2-4 Hale Street, Botany | Building Waste Transfer Facility

Noise and Vibration Impact Assessment

Revision 011

Table 1: Response to NSW EPA Comments (September 2024)

Figure 1: Acoustic site plan identifying the surrounding noise-sensitive receivers and relevant noise monitoring locations (source: SixMaps NSW)

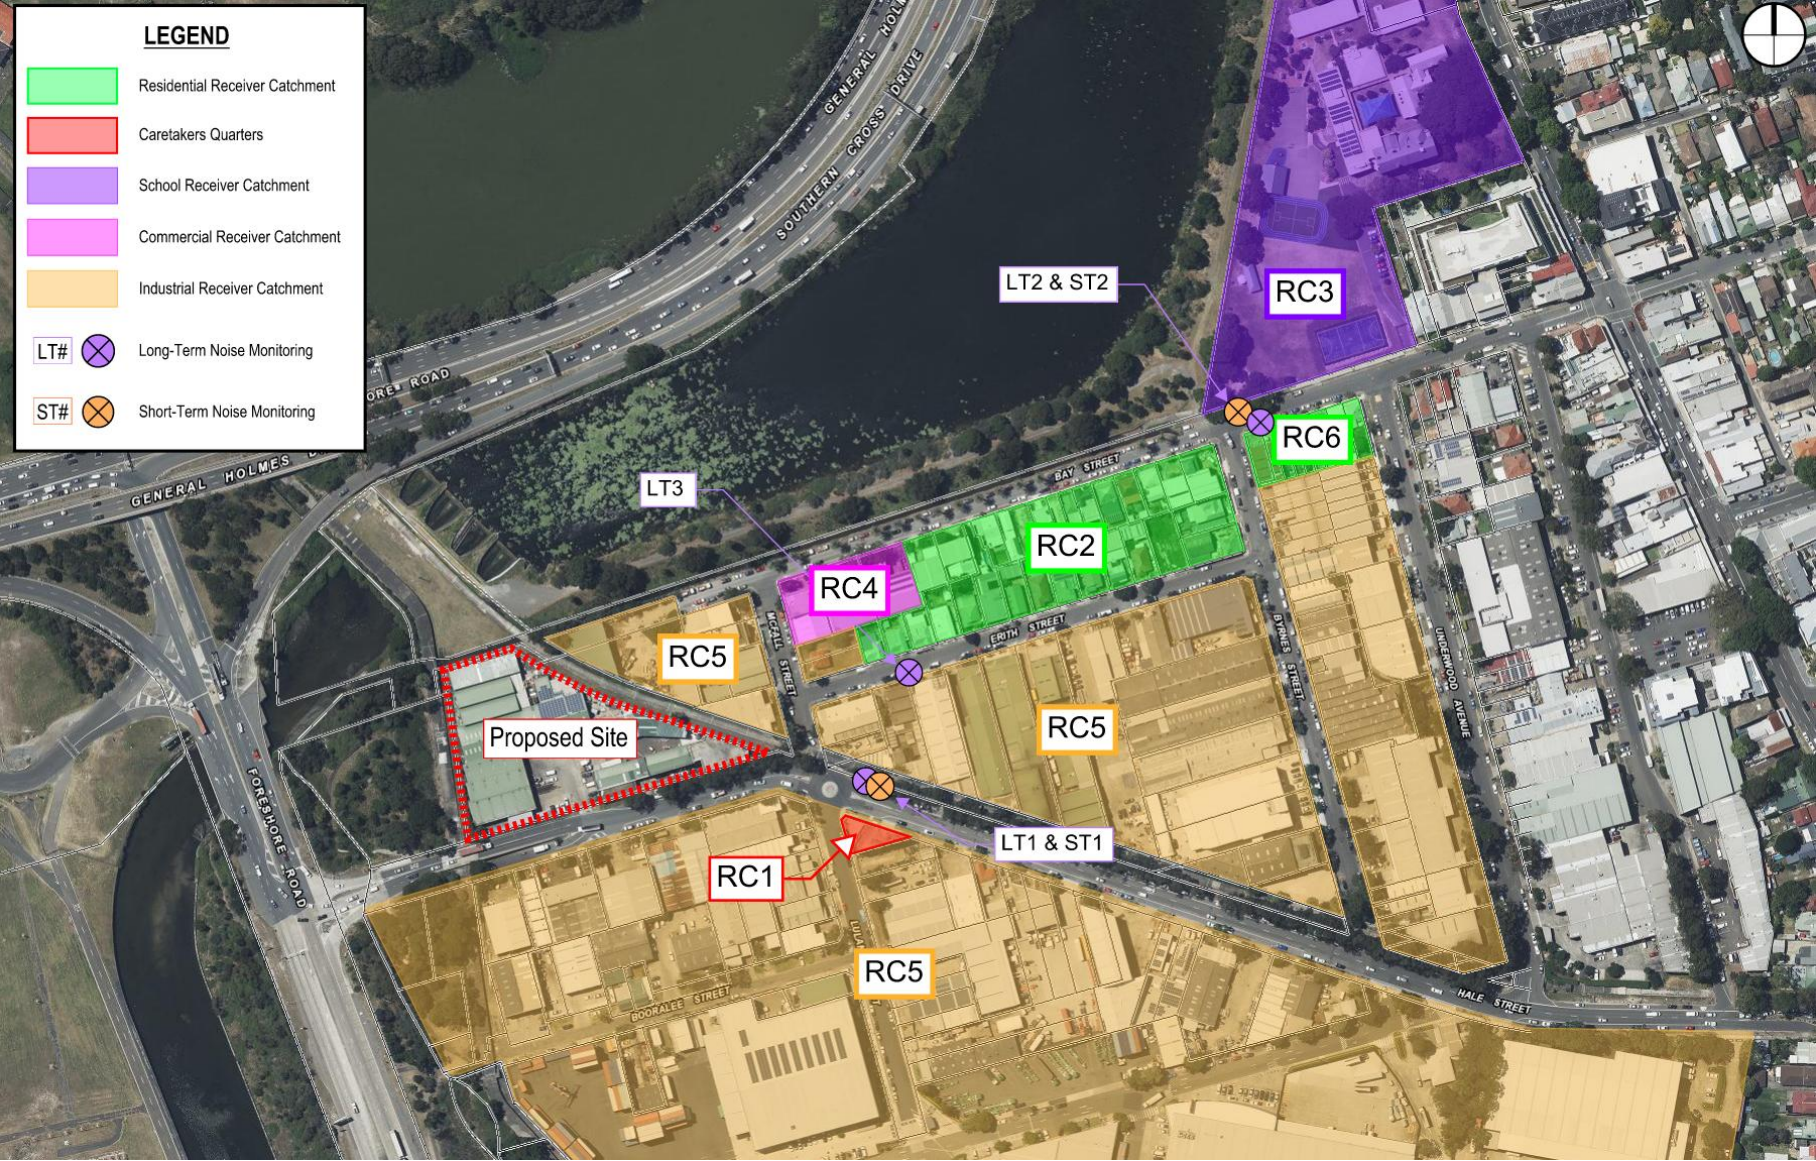
NSW EPA COMMENT	ELAB RESPONSE	REPORT REFERENCE
<p>Identification of sensitive receivers</p> <ul style="list-style-type: none"> The assessment has categorized nearby residential areas into two groups: RC1 and RC2. As shown in Figure 1 and Table 2 of the NVIA, RC1 is a residential area located within the industrial zone, approximately 80 meters from the proposed development. While the specific addresses of the residential dwellings within RC1 have not been provided, ambient noise monitoring has been conducted at a location identified as LT1 - 3 Hale Street Botany, at the corner of Luland Street. Based on the information presented in Figure 1, it appears that LT1 and RC1 are likely located at 3 Luland Street Botany, rather than 3 Hale Street Botany. Further clarification regarding the exact locations of RC1 and LT1 is necessary. The assessment currently does not include or consider the potential noise impacts on residential properties located on Erith Street, approximately 100 meters from the proposed development. It is essential to evaluate the noise exposure of residences on the northern side of Erith Street within the NVIA. A comprehensive land use survey should be conducted to accurately determine the location of sensitive receptors, such as residential properties, schools, and hospitals, in relation to the proposed development. This information will be crucial for assessing potential noise impacts and implementing appropriate mitigation measures. 	<p>Table 5 and Figure 3 have been updated to clarify the location of residential receivers RC1 (3 Luland Street, Botany). The residences along Bay Street and Erith Street have also been separated into two receiver catchments (RC2 and RC6).</p> <p>Also see updated report Sections 1.4 and 6.1 relating to project noise emission targets applicable to the caretakers quarters at receiver catchment RC1 in lieu of residential criteria.</p> <p>The Erith Street residences approximately 100m from the proposed development were previously assessed as RC2 (specifically 26 Erith Street, the western-most residence closest to the proposed development). An updated site map and receiver catchment description is provided in Table 5 and Figure 3 to reflect this.</p> <p>The NSW Government Sharing and Enabling Environmental Data (SEED) land zoning maps are referenced in Figure 2 to determine the land zoning of nearby development, and to determine the most affected receivers surrounding the proposed development.</p> <p>The corresponding assessments in Section 7 and 8 have been updated to incorporate specific land zoning where applicable.</p>	<p>Section 3.1</p> <p>Section 3.1</p> <p>Section 3.1</p>
